New York City Council

Committee on Waterfronts & Committee on Environmental Protection

RE: Committee Hearing on the Rahway Arch Site Remediation, June 12, 2014

Subject: Remedial Action Workplan for Rahway Arch Properties Site; Block 602, Lot 1 and 8; Block 603, Lot 1; Block 705, Lots 17 and 18; Carteret, New Jersey 07008 dated November 27, 2012 and prepared by EastStar Environmental Group, Inc. for Rahway Arch Properties, LLC.

HURRICANE SANDY ACTUAL FLOODING
October 29, 2012, 9:30 pm
Federal Emergency Management Administration

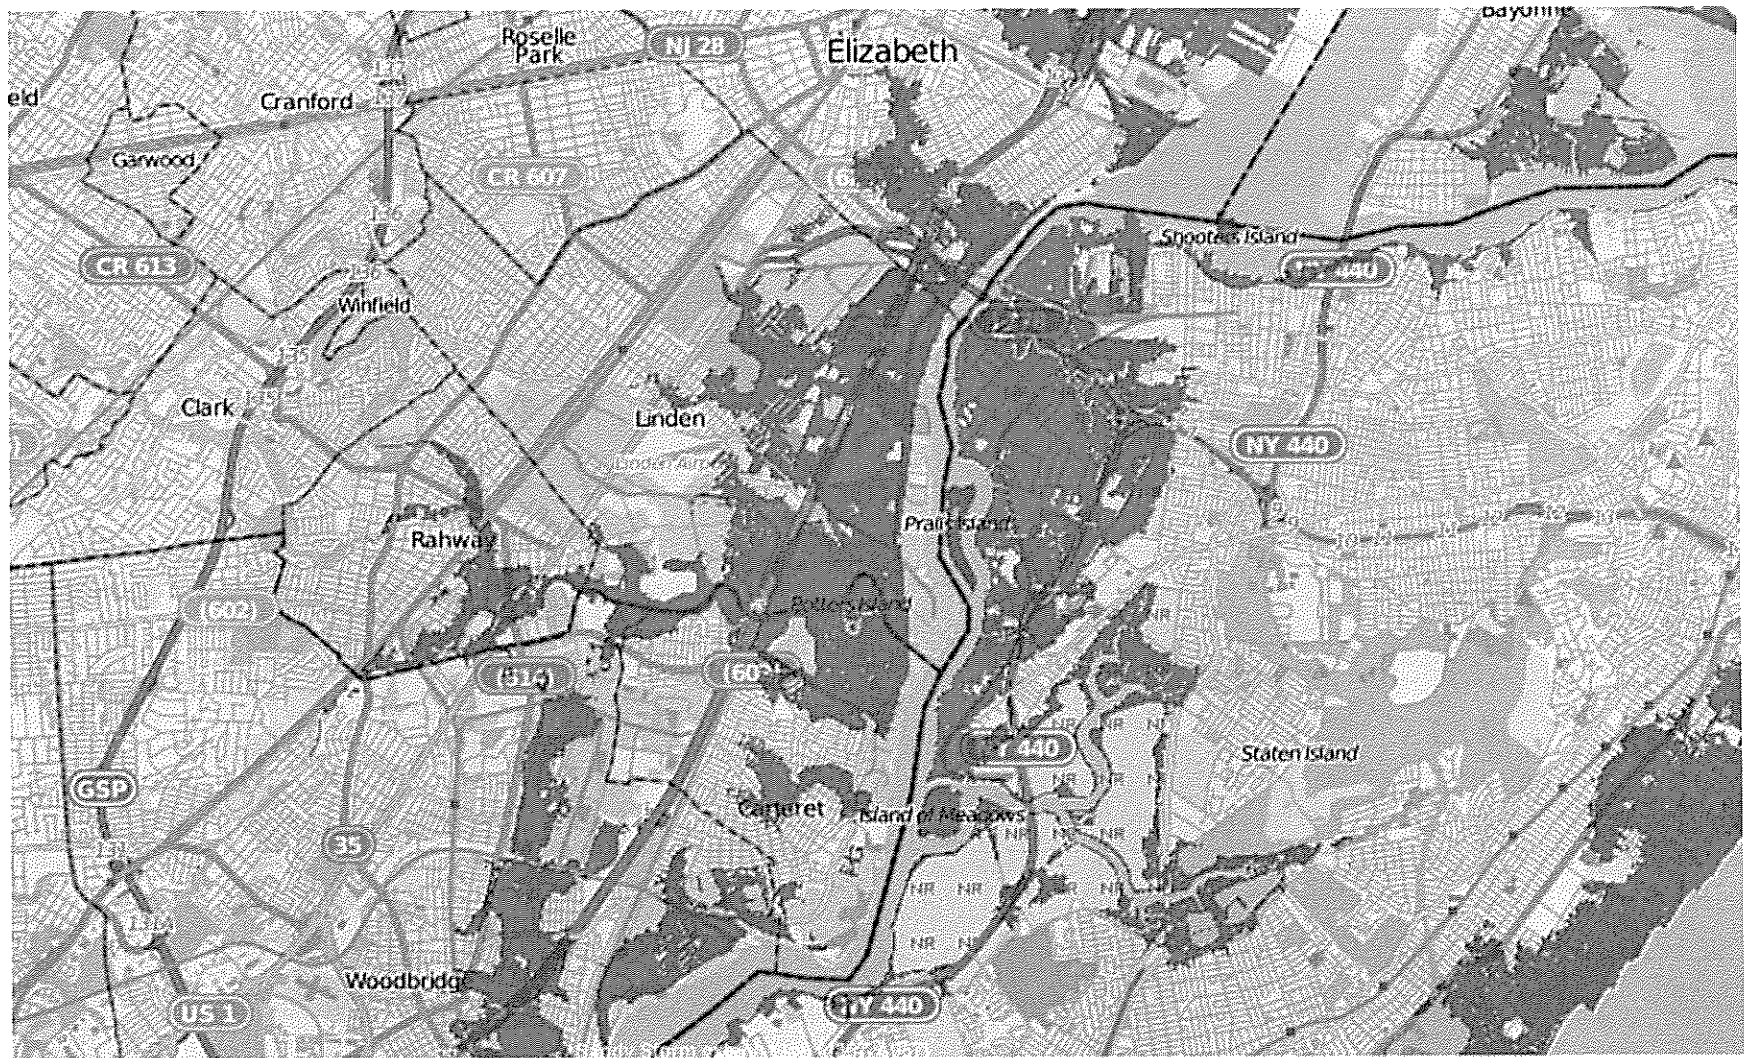
Unanswered questions on flooding impacts

DEP is sending letters to flood-prone communities stating that there need be no concern about flooding, because the area to be filled with contaminated soils only covers a “flood fringe area that acts as storage for flood waters caused by fluvial flooding.”

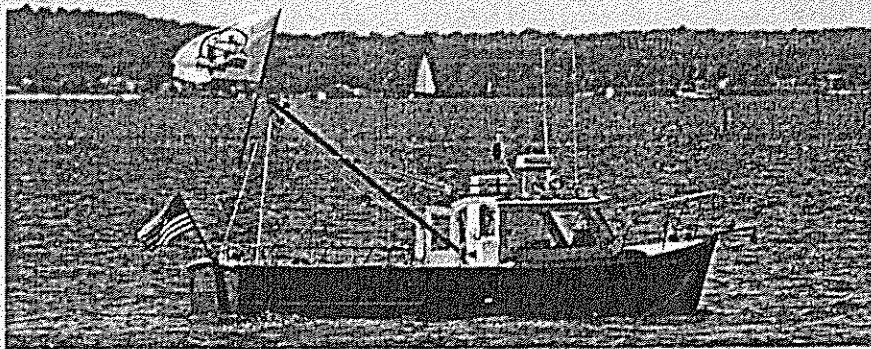
FEMA's newly released National Flood Hazard Layer shows a regulatory floodway surrounding the entire Rahway River boundary of the project site, extending to the mouth of the Arthur Kill.
